Addendum 78 – UN Regulation No. 79

Revision 4 - Amendment 9

Supplement 8 to the 03 series of amendments – Date of entry into force: 4 January 2023

Uniform provisions concerning the approval of vehicles with regard to steering equipment

“5.6.4.8.2. Detection area on ground level

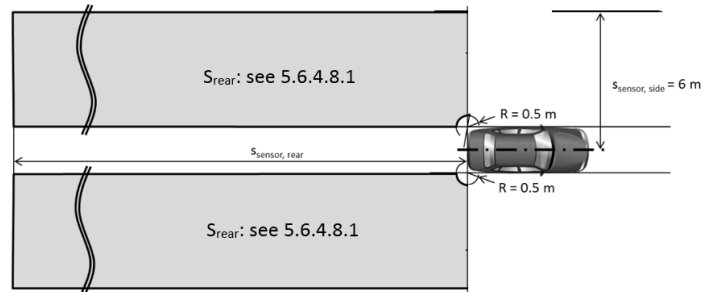
Paragraph 5.6.4.8.2., amend to read:

The vehicle system detection area on ground level shall be at minimum as shown in the figure below.”
